PROJECT TITLE
TWICKENHAM RIVERSIDE

DRAWING TITLE
General Arrangement Plan

ISSUED BY	London	T: 020 7467 1470	
DATE	JULY 2021	DRAWN	ER
SCALE	@A1 1:250	CHECKED	TW
STATUS	Tender	APPROVED	AH

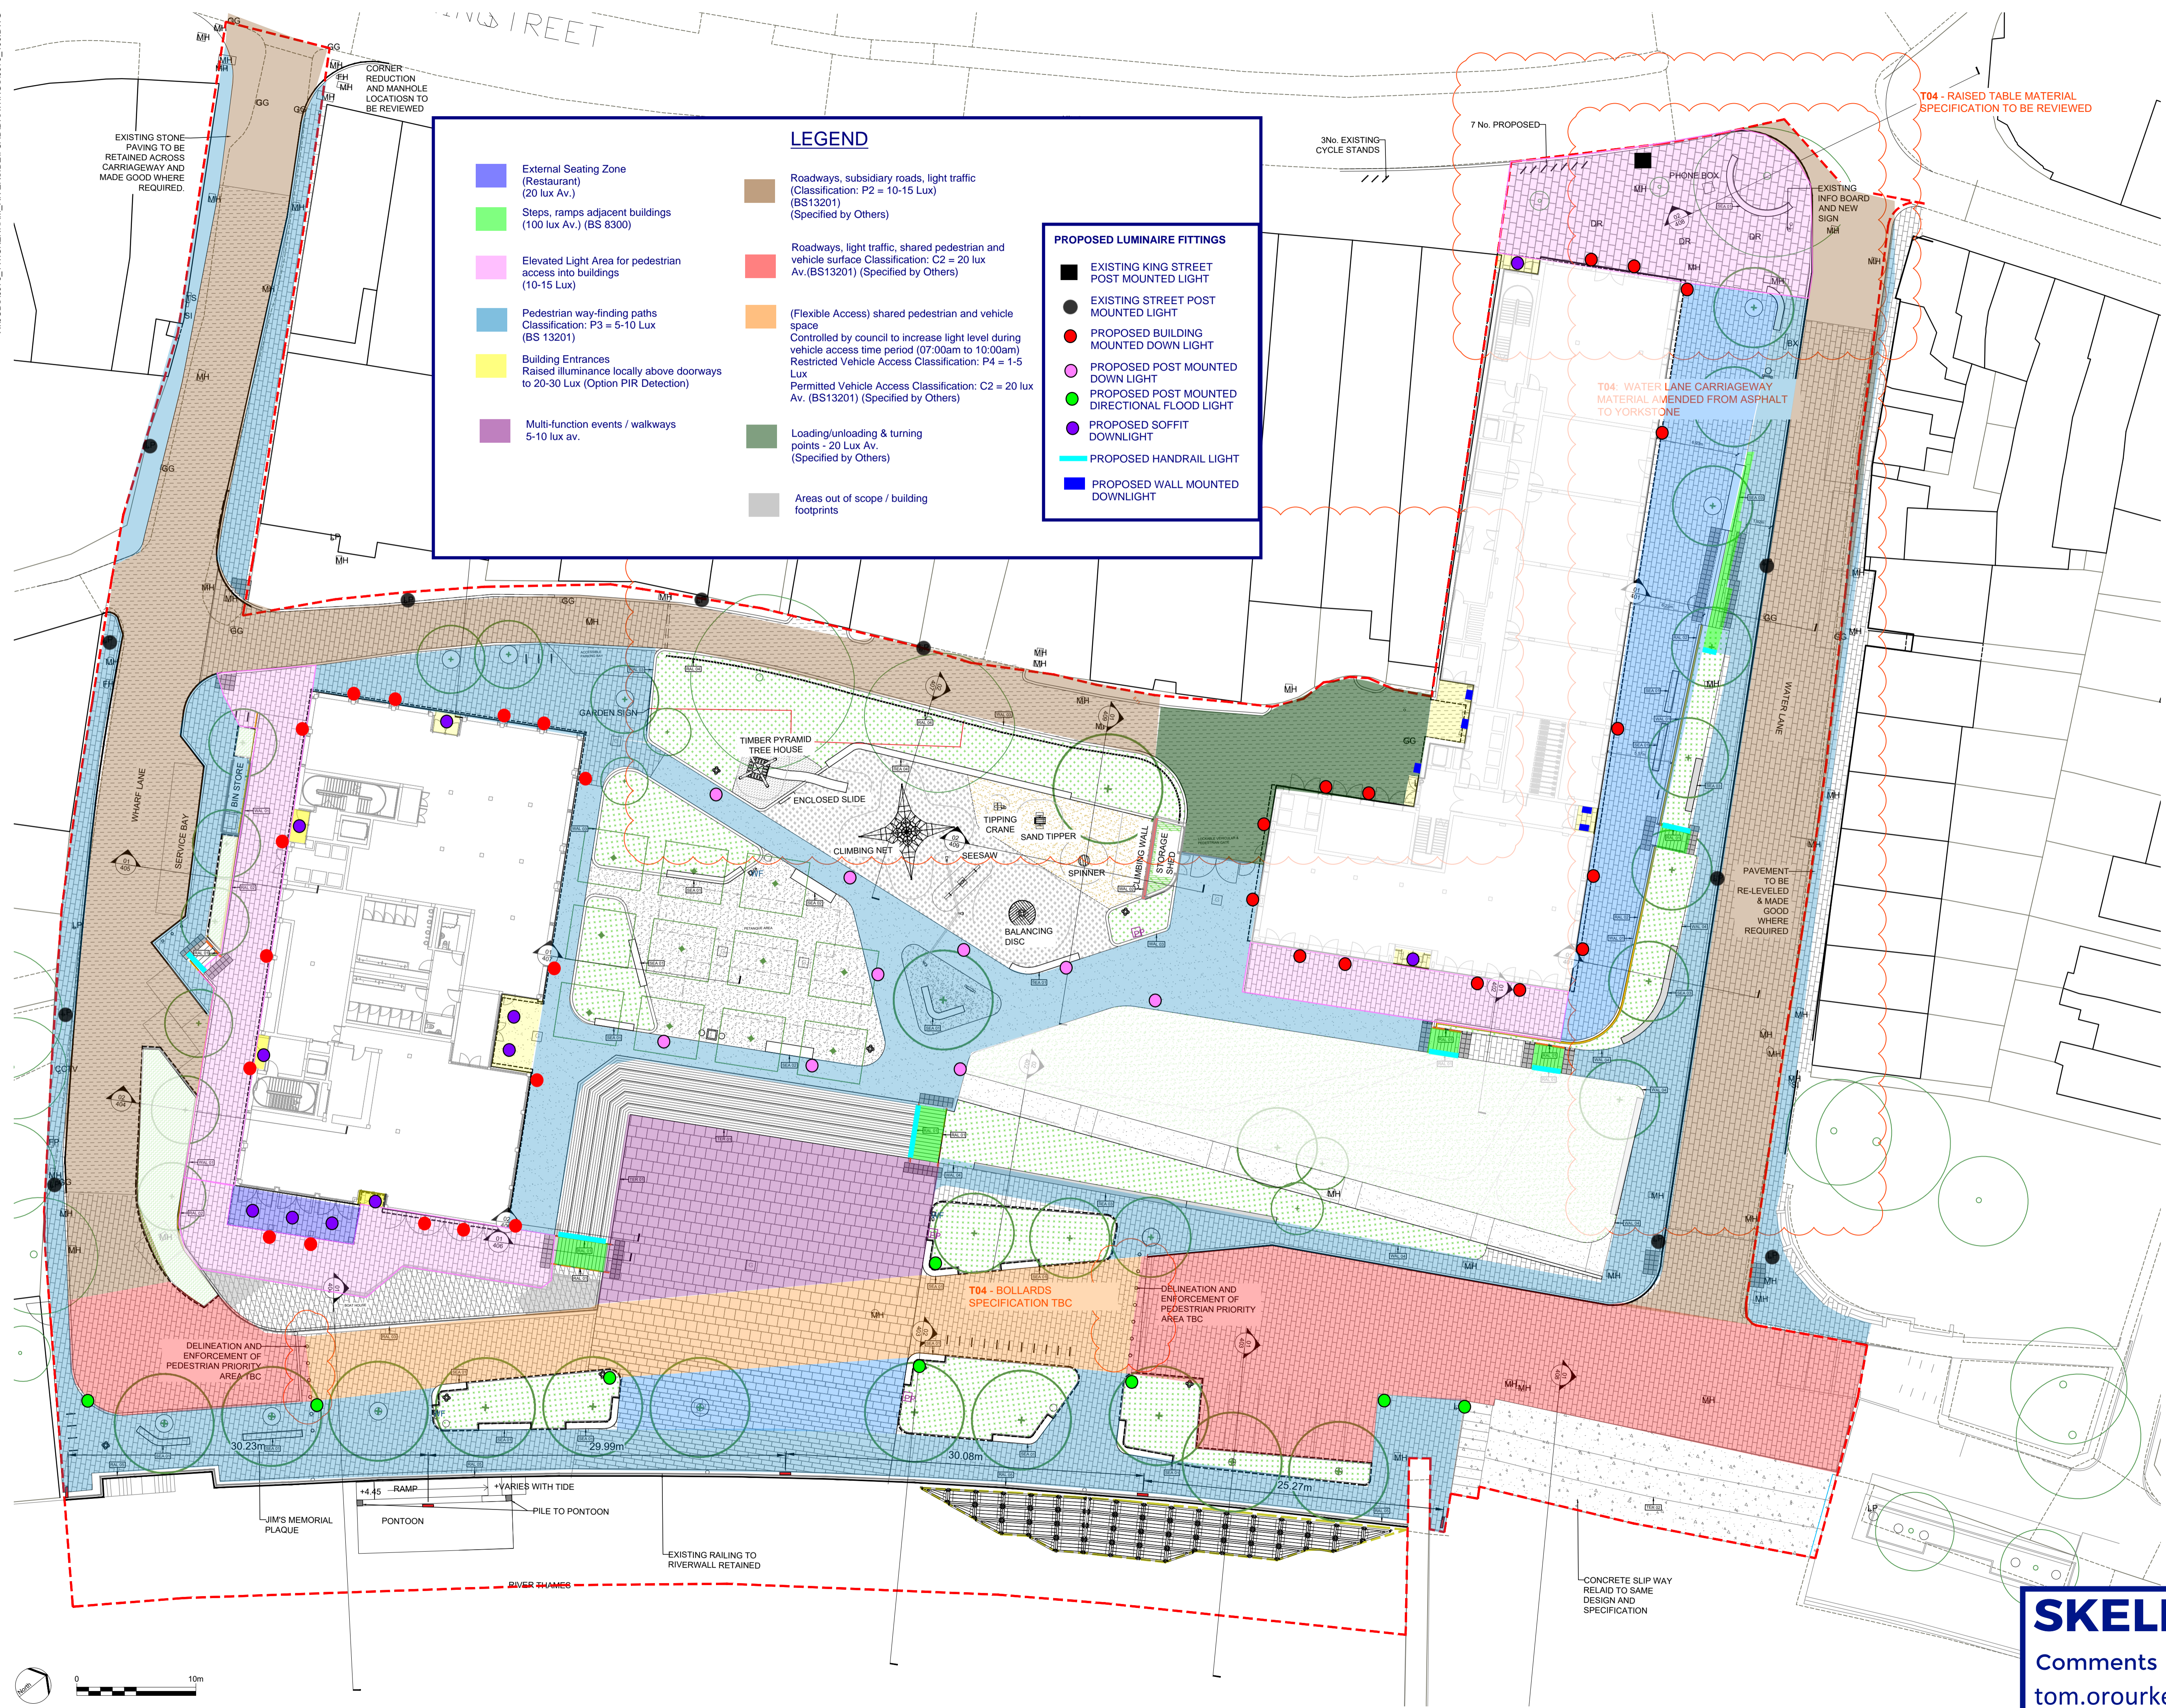
T04 - RAISED TABLE MATERIAL SPECIFICATION TO BE REVIEWED

T04 - WATER LAKE CARRIAGEWAY MATERIAL AMENDED FROM ASPHALT TO YORKSTONE
